**Proposal for 10. series of amendments of UN Regulation No. 107
(M2 and M3 vehicles)**

Glass breaking device efficiency

I Proposal

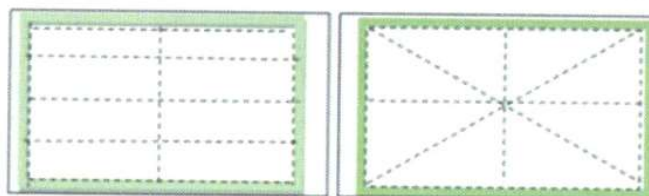
- 7.6.8.2.2.5. The ~~inner~~ **surfaces** of each emergency window may be fitted with a plastic film to enable the person to remove the window pane or panes ~~with his hands~~. ~~{The plastic film shall be cut at the outer edge of the emergency window and following the a patterns e.g. shown in picture XX below}. In case of fitting a plastic film to the emergency exit, it shall be compatible with the device and shall not reduce its efficiency. In addition, the characteristics of the approved glazing shall remain unchanged. The device for breaking the glass for the emergency windows at the rear of the vehicle shall be positioned either centrally above or below the emergency window or, alternatively, a device shall be positioned adjacent to each end of the window.~~
